RE: Rault Residence
209 Bedford Banksville Road
Town of North Castle, NY

The revisions depicted on the above noted plans reflect responses to comments outlined in the Town of North Castle Planning Department Memorandum, dated December 5, 2022. For ease of review, we have repeated and enumerated the comments in italic print, followed by our responses:

Town of North Castle Planning Department, dated December 5, 2022

F.A.R.

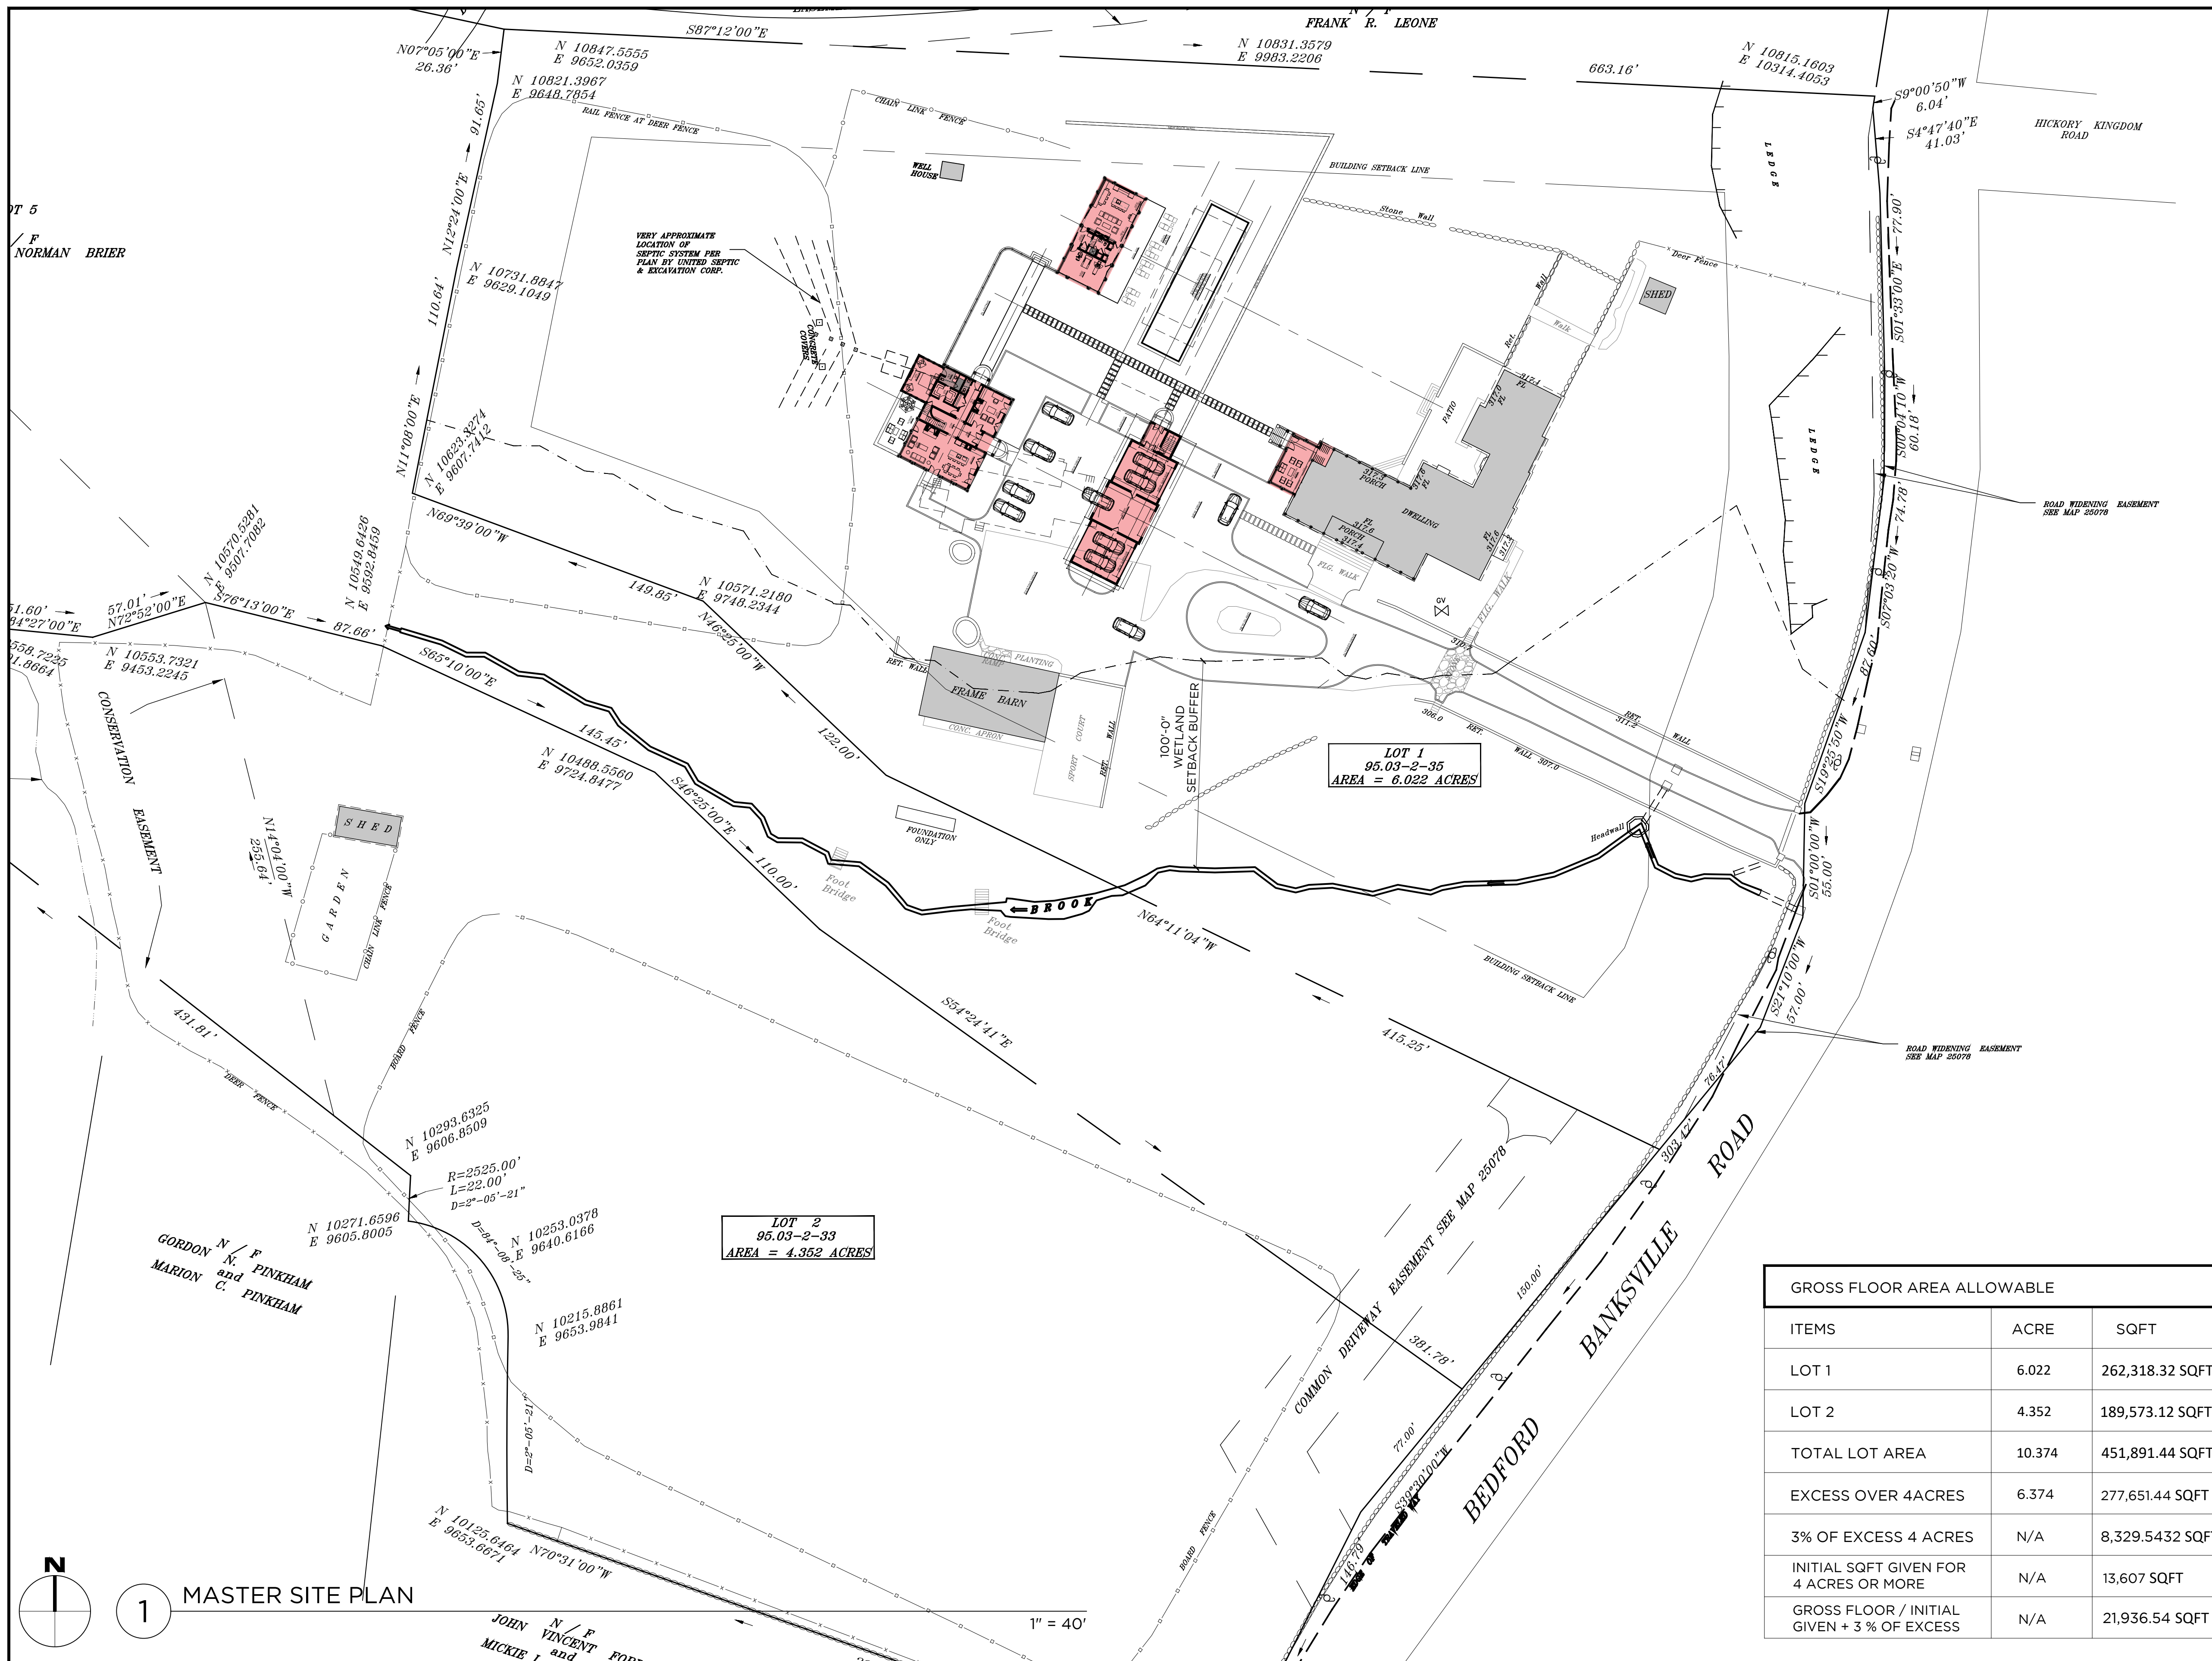
The Applicant should provide gross floor area backup exhibits for review.

The site plan should be revised to include a chart that depicts the square footage of each structure, the number of stories, the height and the gross floor area percent of the Main House (with calculations).

Comment No. 13

See sheets “F.A.R.”, “F.A.R. 2”, and excel spreadsheet for areas

This chart has been added to sheet “F.A.R.” and “F.A.R.2” for areas and sheet “zoning” for building heights.

The proposed principal building's sf is 11,771.14.
The proposed accessory apartment sf is 3,884.
33% of 11,771.14 sf is 3,884 sf.
See calculations on sheet "F.A.R."

SITE PLAN

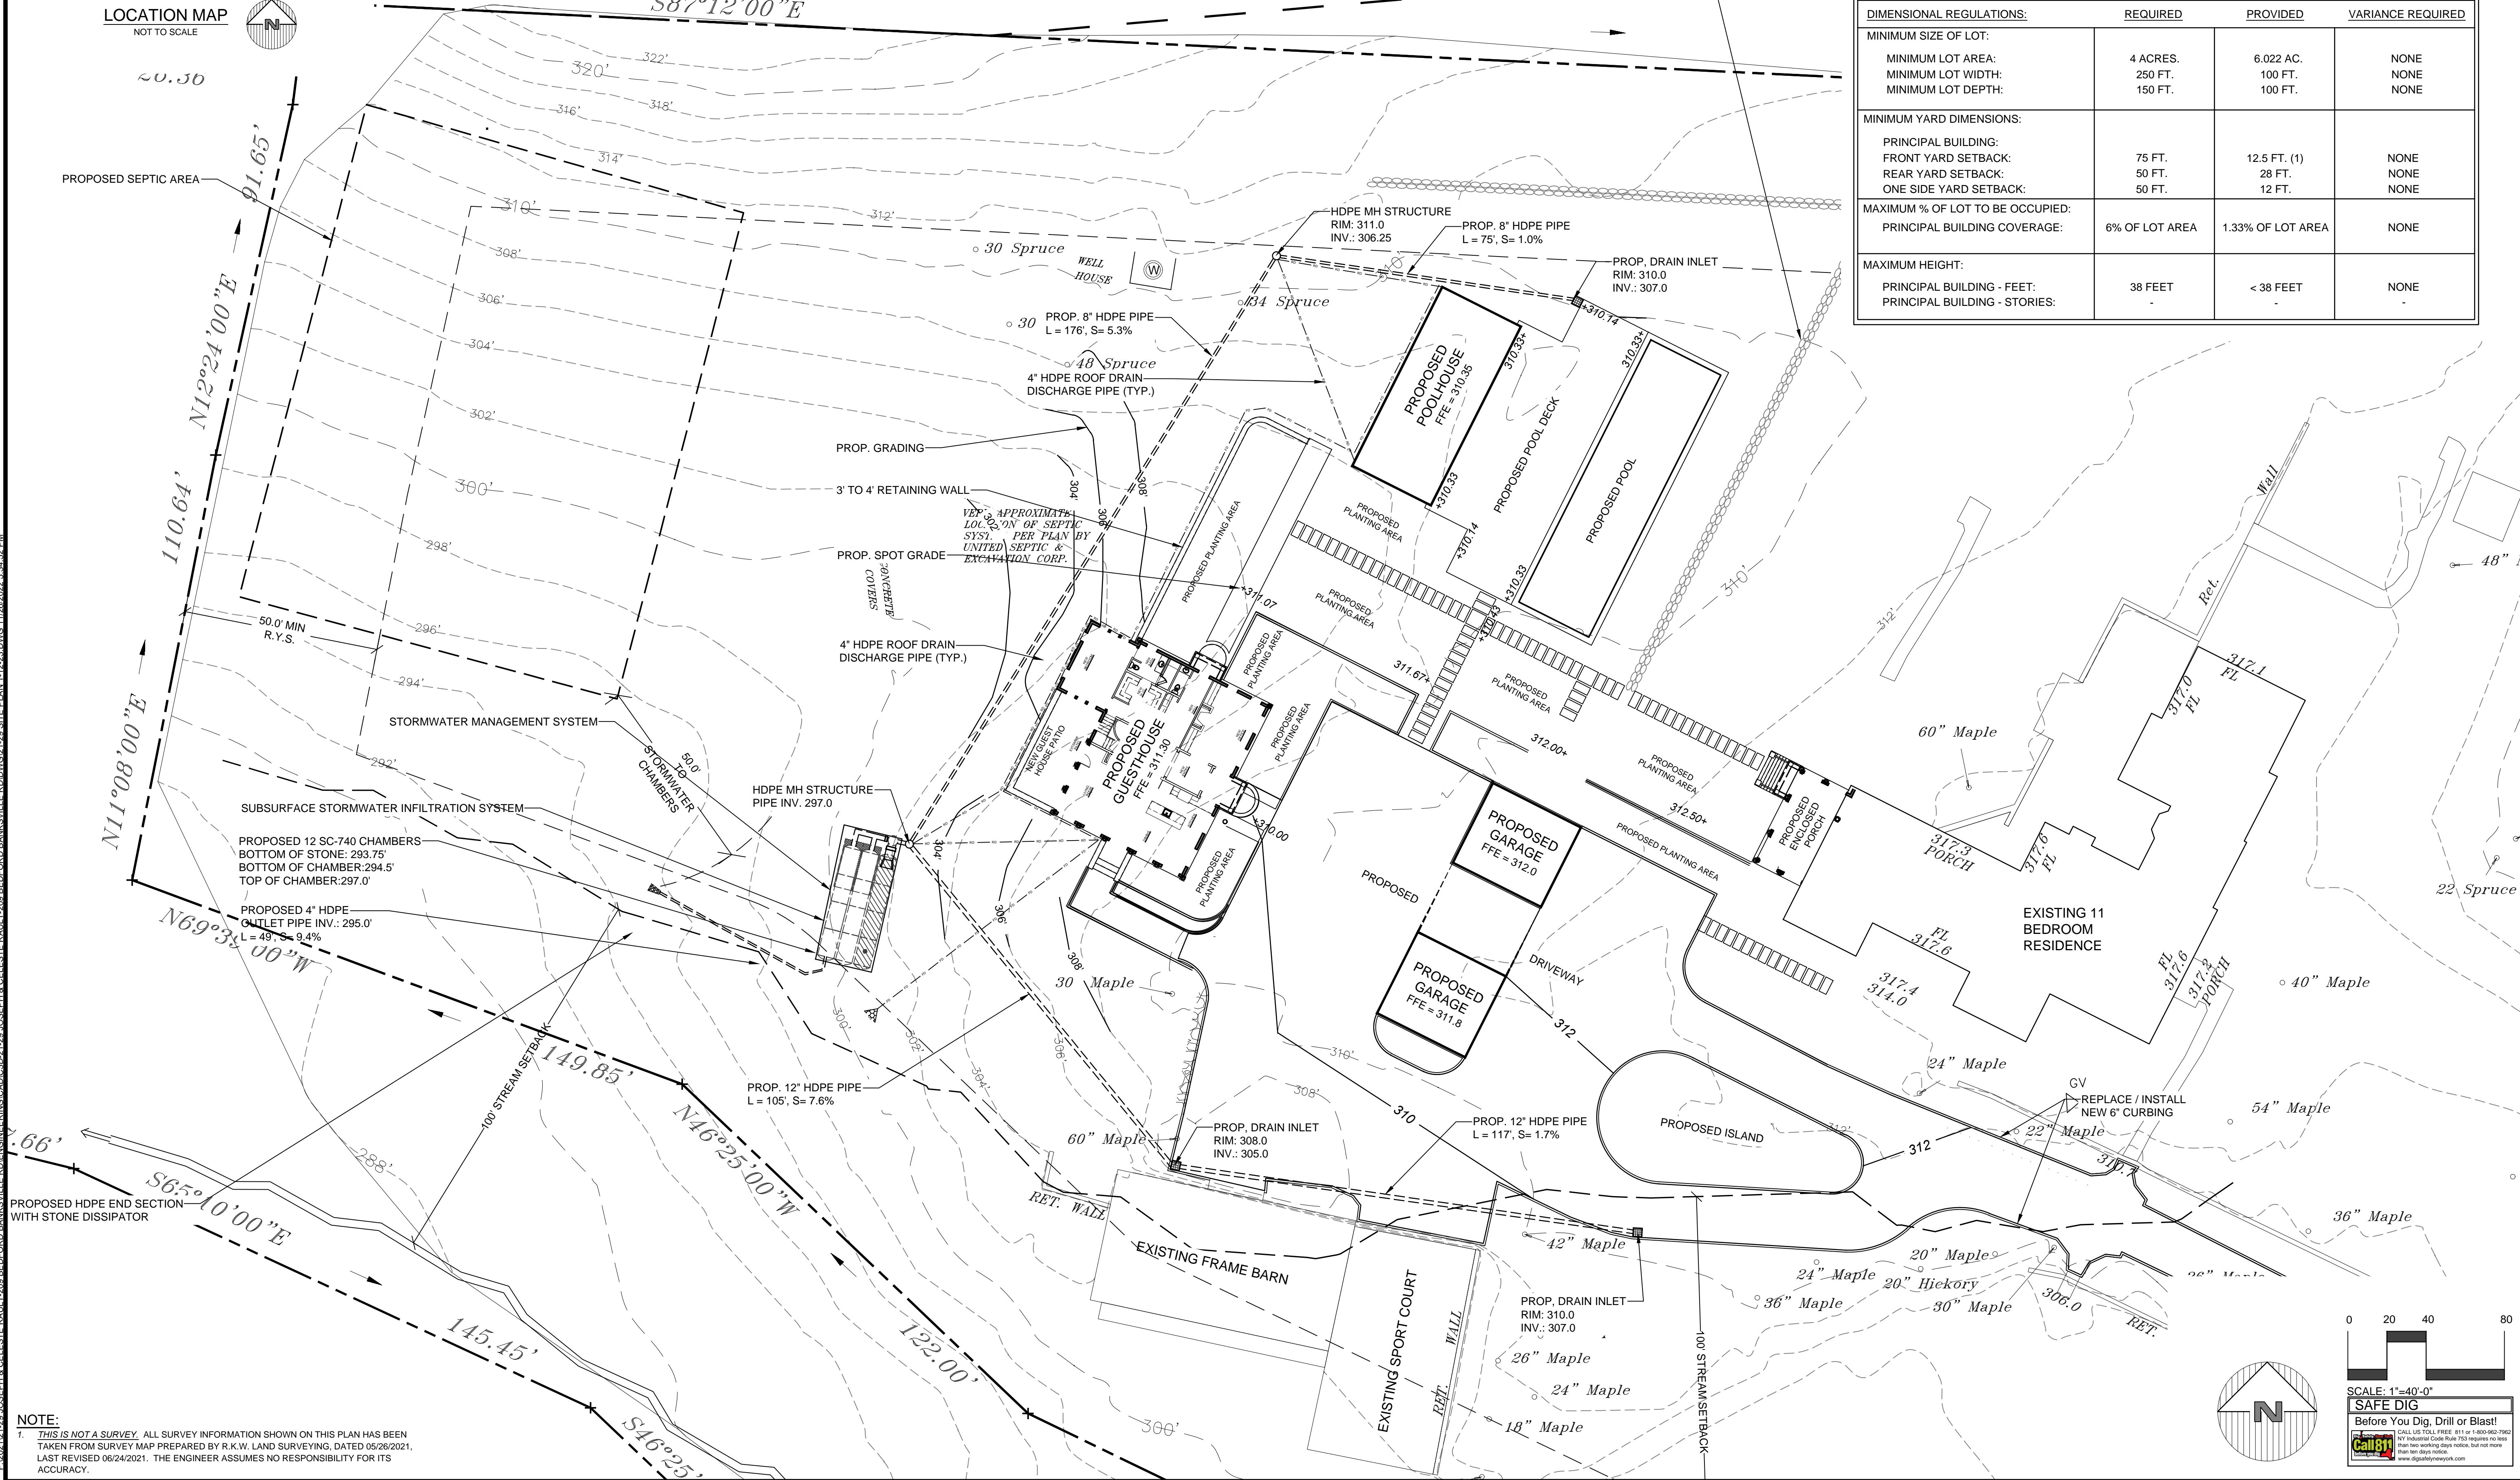
The site plan should be revised to include an updated zoning chart that includes a setback analysis for all structures, a height analysis from all buildings and a Building Coverage analysis that includes a total building coverage for the site (not just the principal building).

The site plans should be revised to depict the Town-regulated wetland/stream and 100 foot buffer on all the site plans. It is not clear whether any disturbance is proposed within the buffer area.

We have included a zoning chart. (See site plan “Zoning”)

The buffer line has been added to all the site plans.
